**Operator: CIVITAS NORTH**  
**Location Name: Hunt Fed 8-60 19 Pad**  
**Loc ID: 454749**  
**Inspection: 708200771**

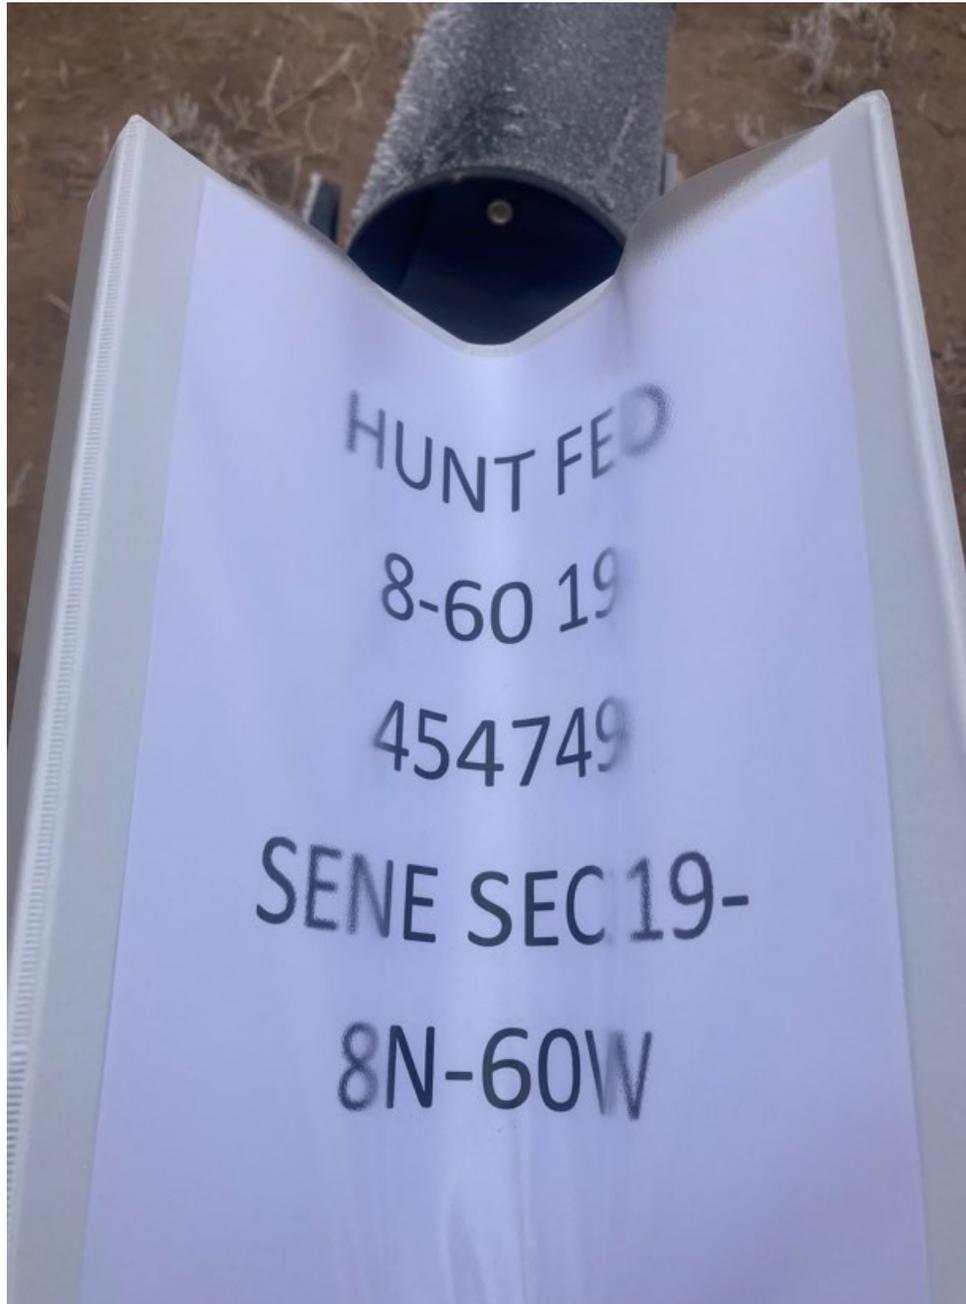
**CA:** This location does not comply with Rule 406.c. At the time of this inspection, Staff was unable to locate a copy of the approved Form 2A while on location. A mailbox at the location entrance contained only a Weld County grading permit; no other permit materials were found within the mailbox, or elsewhere on location. Refer to the attached inspection photos. Comply with Rule 406.c. The location will remain out of compliance until the corrective action has been resolved.

**CA Resolution:** Form 2A has been placed in mailbox onsite to comply with Rule 406.c.
